BATHROOM PLAN

CHANGES DESIRED IN PLAN FOR BATH No. 5

25X1A1d [redacted] No. 4890

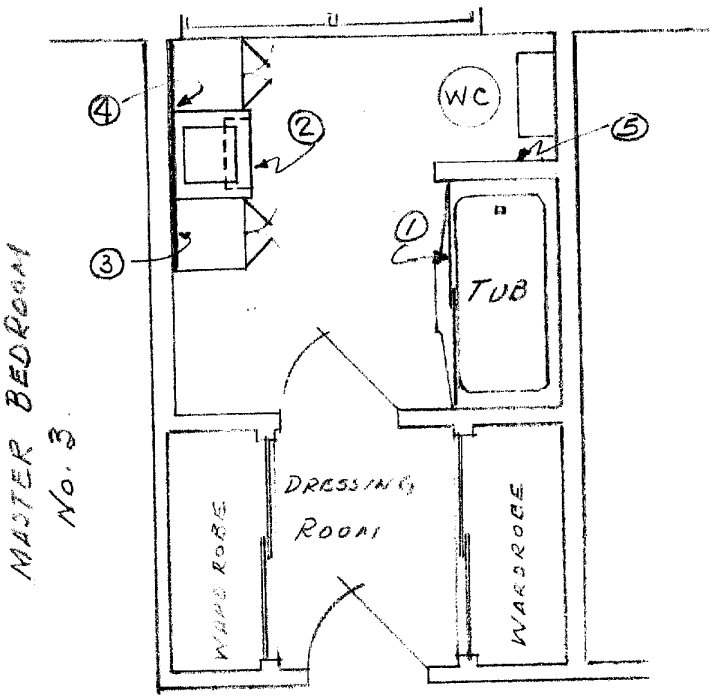
✓ (1) RELOCATE WC & TUB, ELIMINATING SHOWER, PROVIDING SHOWER OVER TUB AND FROSTED GLAZED TUB ENCLOSURE WITH SLIDING PANEL AS INDICATED.

✓ (2) PROVIDE & INSTAL STANDARD TYPE LAVATORY-DRESSING TABLE APPROX 62" x 18"; - LAVATORY SIZE 24" x 18" COUNTER-TYPE RECESSED TO PERMIT KNEE SPACE WHILE SITTING.

✓ (3) MIRROR APPROX 3' x 5' OVER TOP OF LAVATORY - DRESSING TABLE.

(4) PROVIDE SERVICE OUTLET FOR ELECTRIC RAZOR AND LIGHTING FOR DRESSING TABLE & TUB.

✓ (5) INSTAL WALL TO CEILING TO ENCLOSE TUB.
